## Landmarks Preservation Commission Planning and Development Services Department

**STAFF REPORT**

**DESIGN REVIEW****AGENDA ITEM 4A: 811 N. Ainsworth***Nick Holt, York Enterprises***BACKGROUND**

Permit Number: HDR22-0020

**A-3.0**

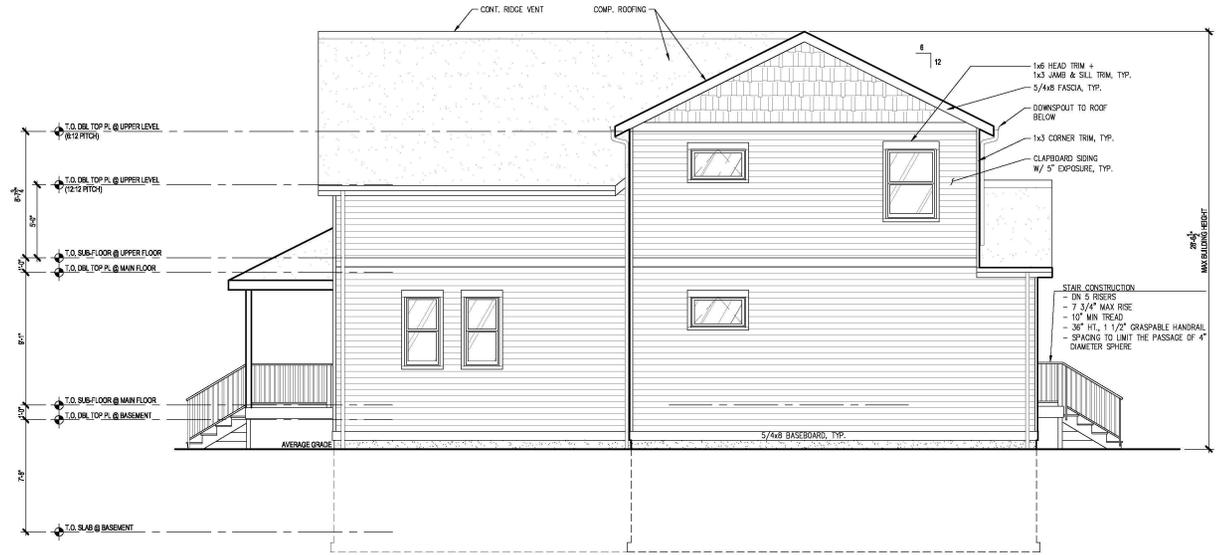
10. The guideline for "sense of entry" states, "Entrances should be located on the front facade of the building and highlighted with architectural details, such as raised platforms, porches, or porticos to draw attention to the entry. Entrances not located on the front facade should be easily recognizable from the street." The proposed design includes a clearly defined porch located on the front elevation, thus appearing to meet this guideline.

11. The guideline for "roof shapes and materials" notes that roof pitches for new structures should be between 5:12 and 12:12, and should utilize elements such as dormers and cross gables to break up large blank surfaces. The proposed design includes a primary 12:12 pitch with a cross gable/shed dormer at 6:12, thus meeting this guideline.
